Objection to Modification SSD 5066 Mod. 1 Moorebank Precinct West

Sharyn Cullis Georges River Environmental Alliance June 2019

Figure 10-1: Proposed biobank site

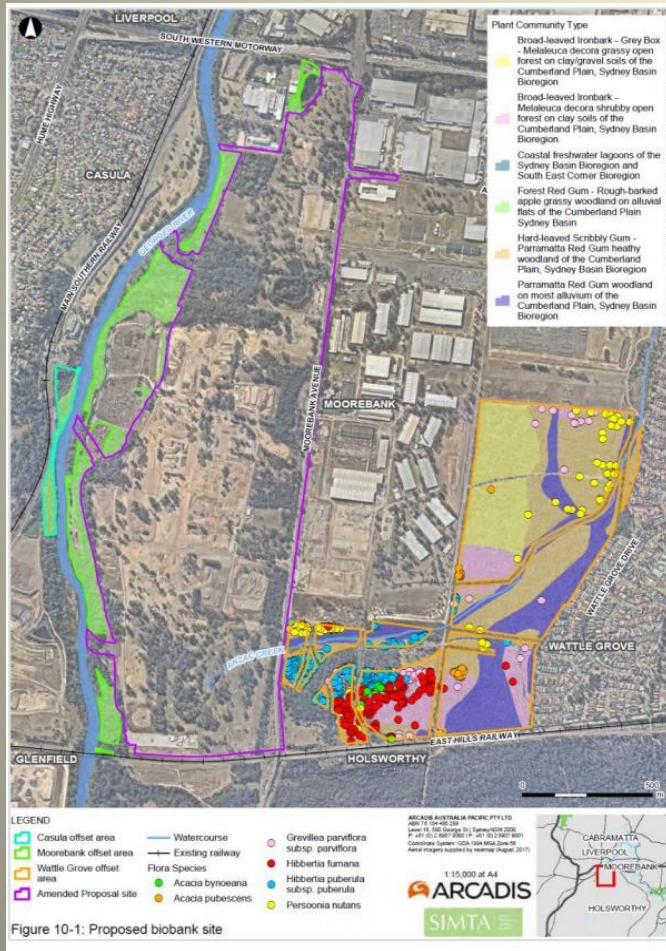
Urban forests are present!

Figure 4 | Approved Layout (source: MOD RTs)

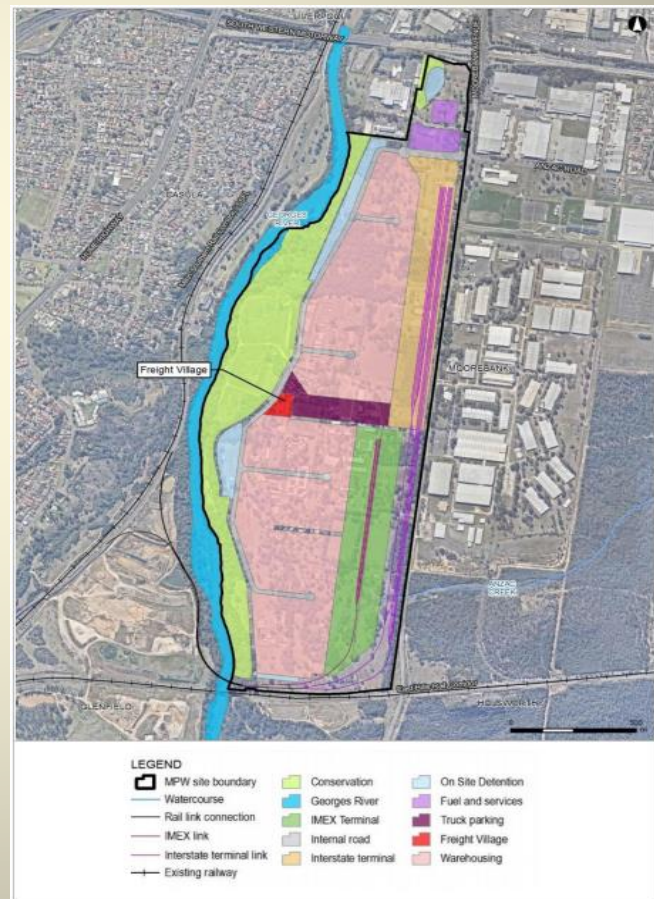
Urban forests will go!
